July 15, 2003 CPC

03PR0299

The Rebkee Company and BB&T
(CVS Pharmacy Store No. 12)

REQUEST: Site Plan Approval.

03PRO299-2

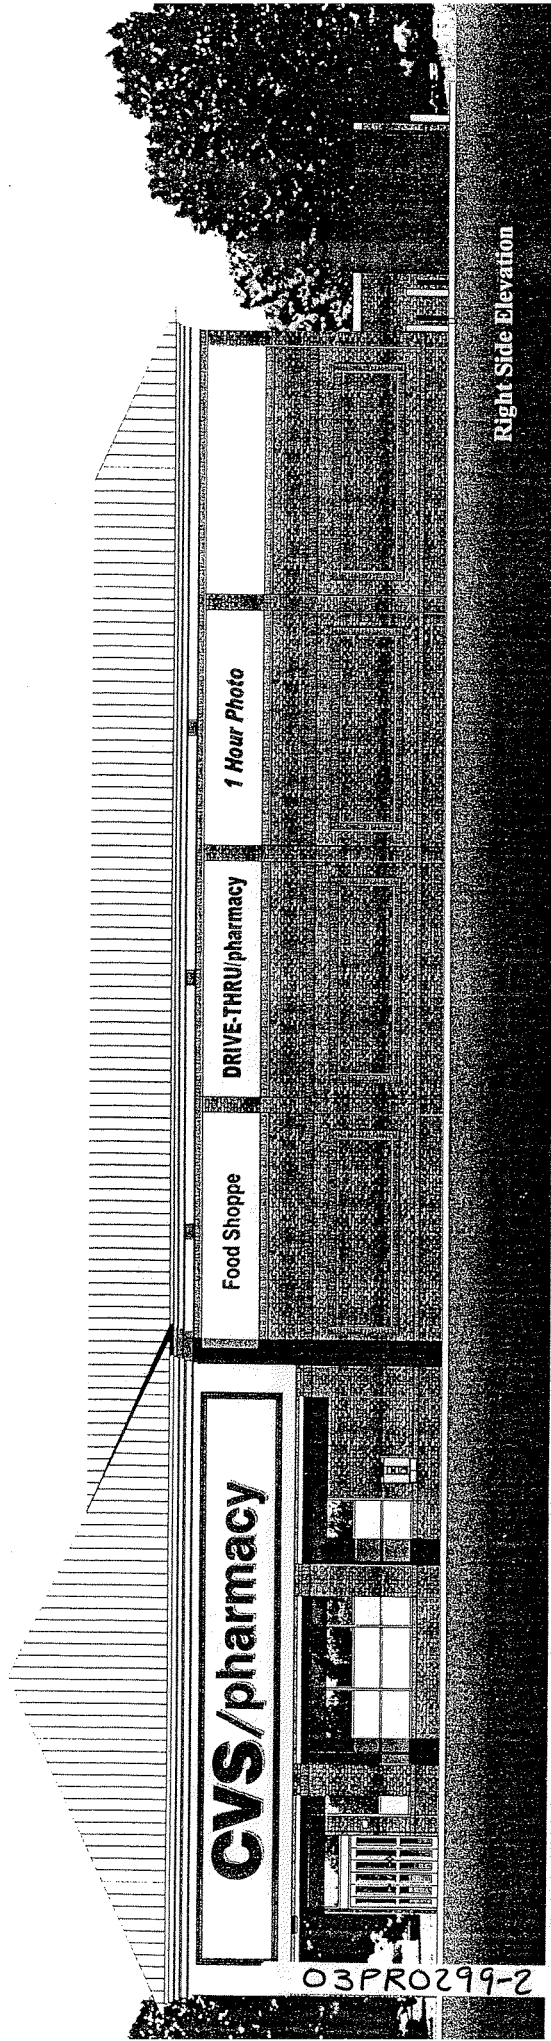
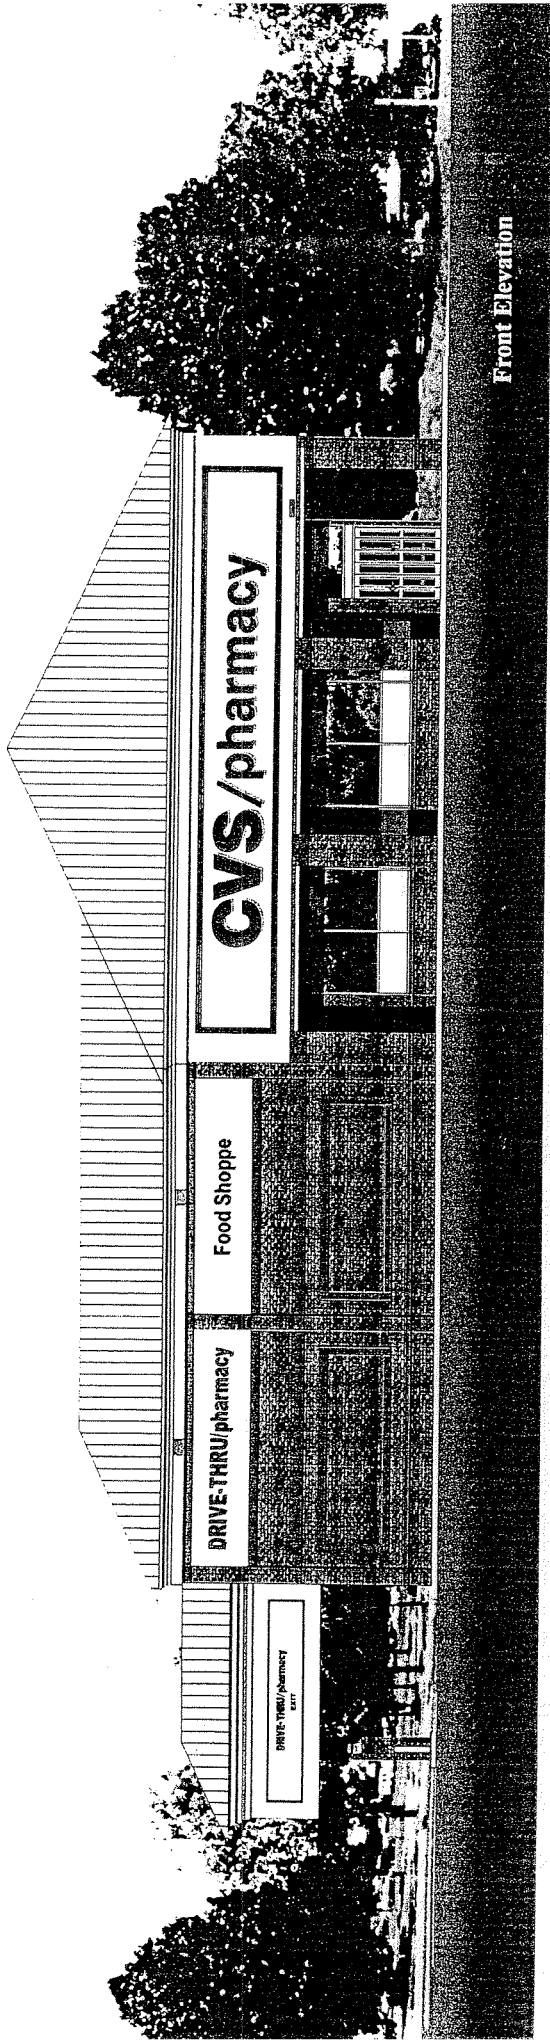
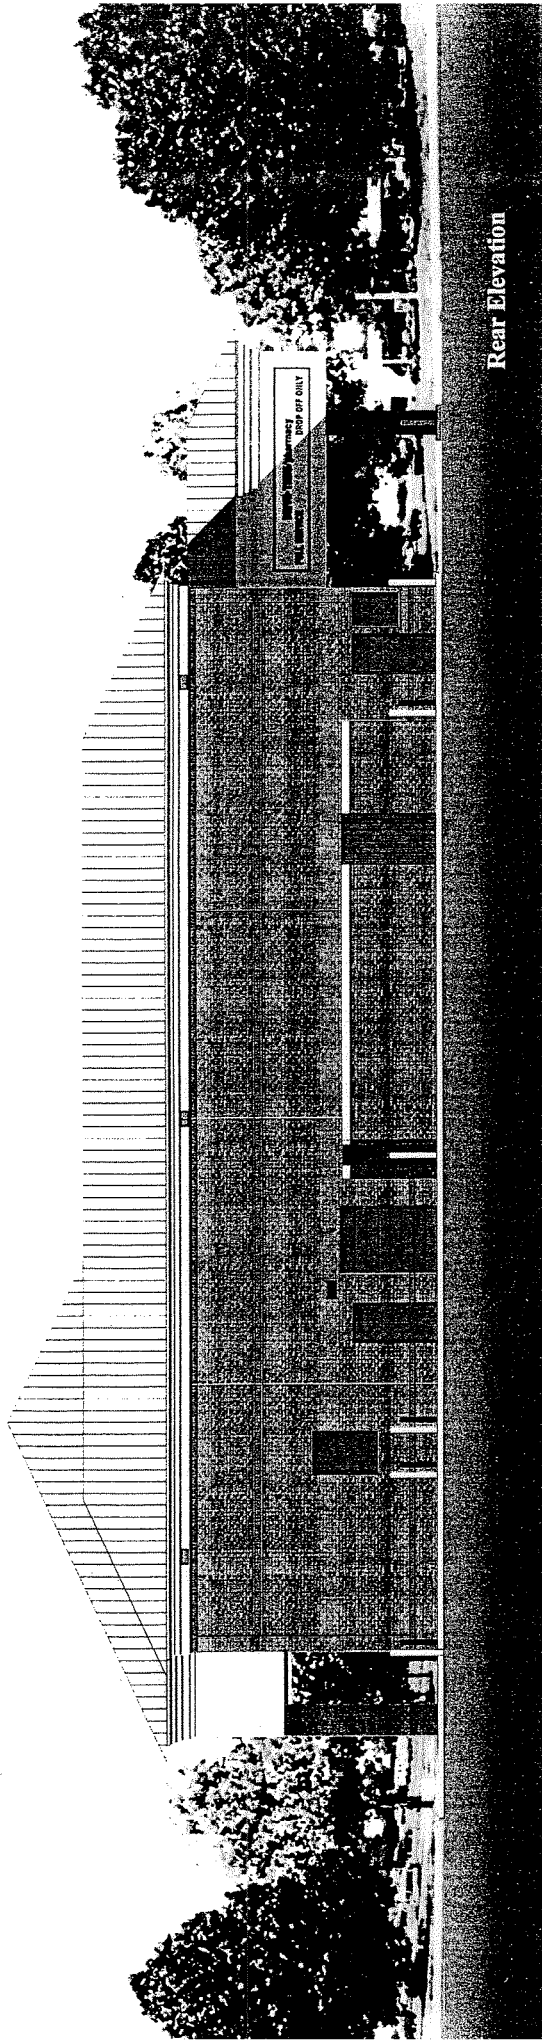
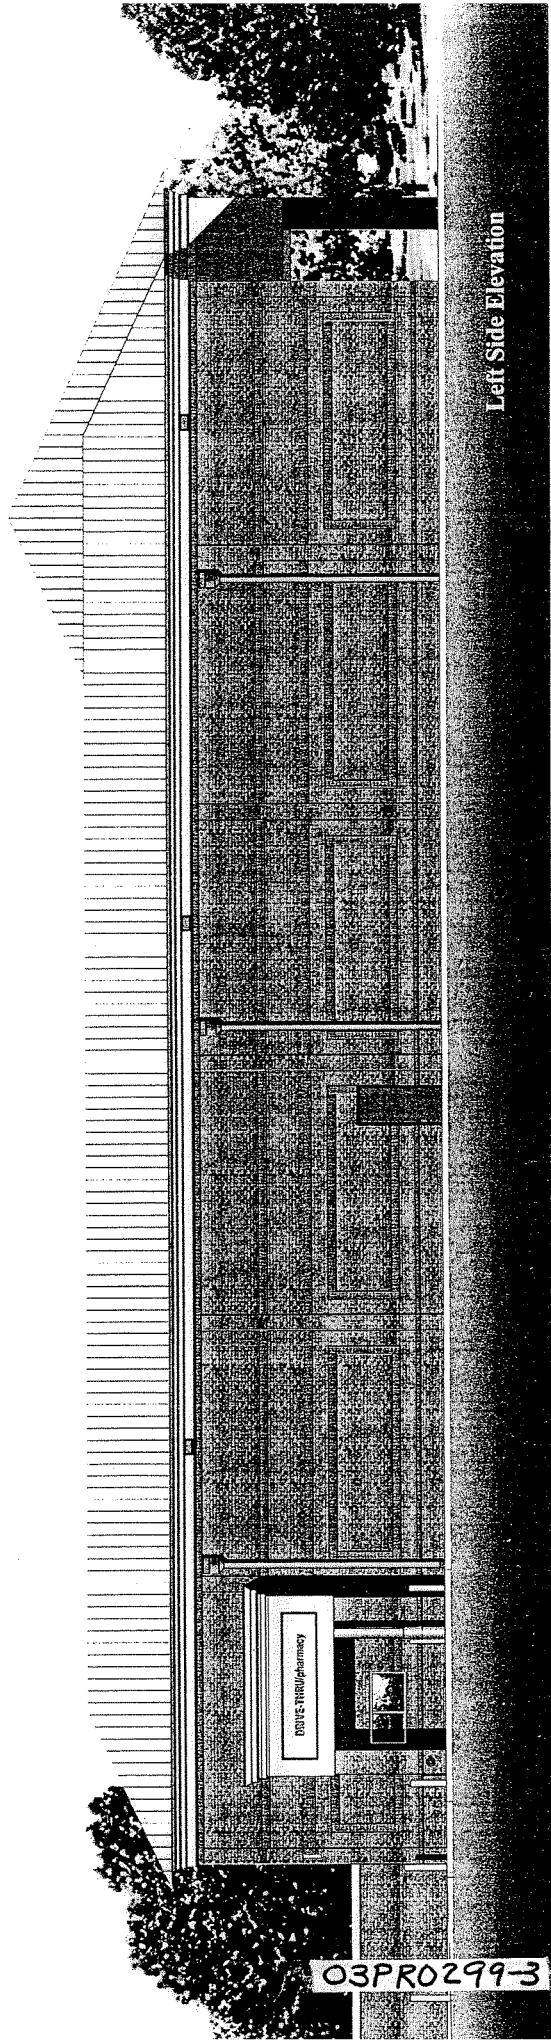
31. Stipulate on the elevation drawing that the roof will be standing seam metal. (P)
32. Stipulate on the elevations drawing that the brick and mortar will match that of the existing buildings. (P)

33. Stipulate on the elevation drawing that EIFS material will match that of existing buildings. (P)
34. The allocation of brick and EIFS on this building must be adjusted so that the appearance is more consistent with the adjacent buildings. (P)

35. The large expanses of brick must be broken up by a method that reads strongly. Slight variations in surface depth do not typically read well when viewed from the road. (P)

36. The adjacent buildings and shopping center use columns or elaborate brick piers. One of these methods or a combination of the two (2) must be used on this building. (P)

38. Preceding comments relating to architecture notwithstanding, the overall image of the adjacent structures is very strong. This building has a very weak styling. This will need to be satisfactorily corrected prior to release of a building permit.
